# Technical Service Bulletin

## MIL on (DTC P0642, P2004, P2008, P3137, P3138 in ECM)

24 08 10 2016868/2 March 3, 2008. Supersedes Technical Service Bulletin Group 24 number 08-02 dated Jan. 17, 2008 to add a reference to RVU CH.

**Figure 1.** The Intake Flap Motor V157 (1).

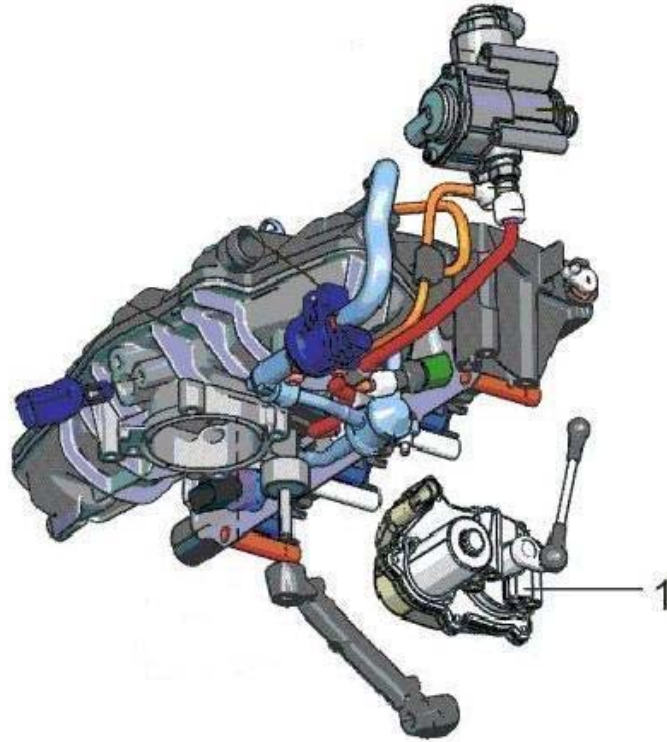
5. Perform basic settings for Intake Flap Motor V157 (channel 142).
6. If the basic settings for Intake Flap Motor V157 cannot be performed successfully, replace the Intake Flap Motor V157.
7. If one or more of the DTCs listed in the condition section are stored in the ECM data memory and the ECM SW was previously updated (the ECM already has the new SW version), replace the Intake Flap Motor V157 even if the basic settings can be performed successfully.
